FORD, JAGUAR, MAZDA, ROVER, VW, EQUIPPED WITH JF506-E

2-3 FLARE OR, SLIPS 3RD, 4TH, 5TH

Figure 1

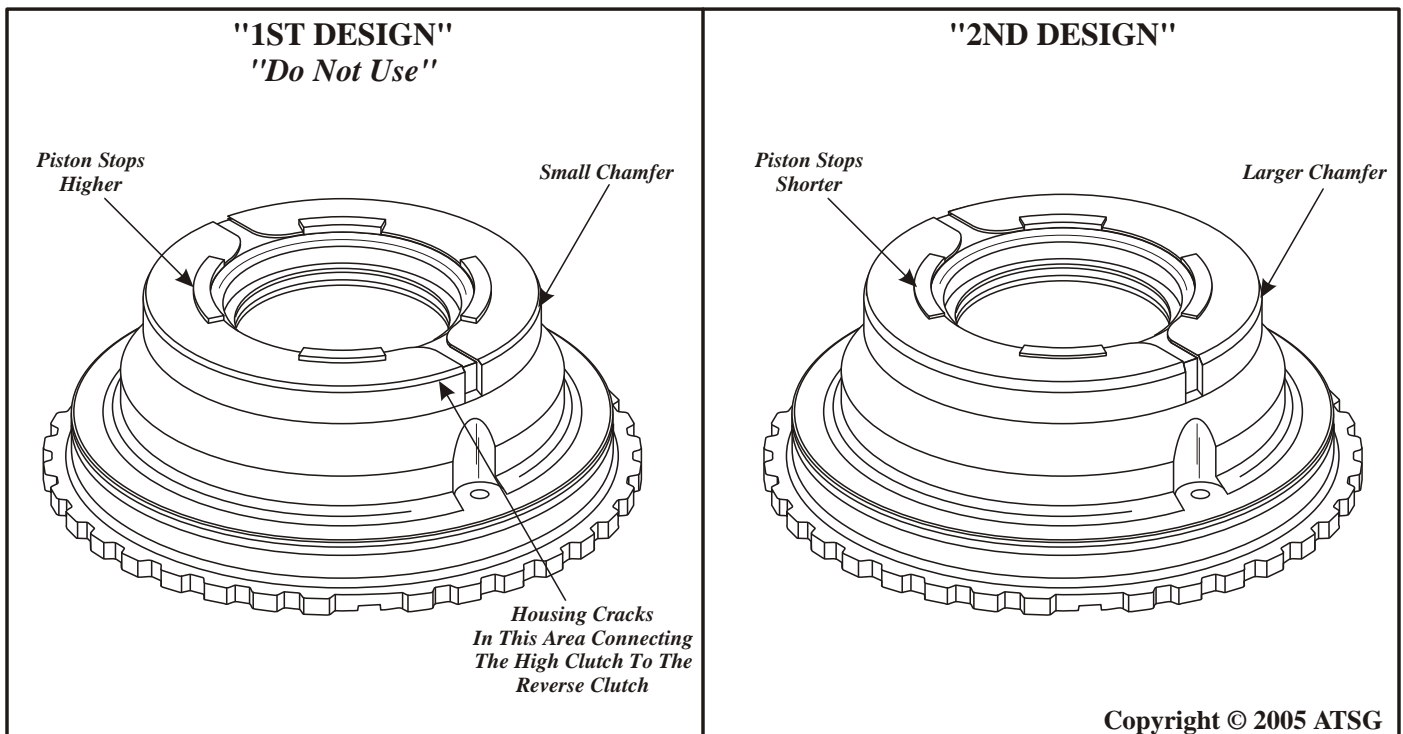
CAUSE: The cause may be, high and reverse clutch piston housing, as shown in Figure 1.

CORRECTION: This crack is *extremely* difficult to detect visually, and if missed will create premature high clutch failure. This piston cracks in an area of the piston that allows the high clutch apply oil to bleed into the reverse clutch circuit, as shown in Figure 1. The reverse clutch circuit is basically an exhaust, when the transaxle is in 3rd, 4th, or 5th gear.

Replace the high and reverse clutch piston housing, as shown in Figure 1. There is now a 2nd design piston available from Mazda. Refer to Figure 2 for an exploded view of the high and reverse drum showing the housing location.
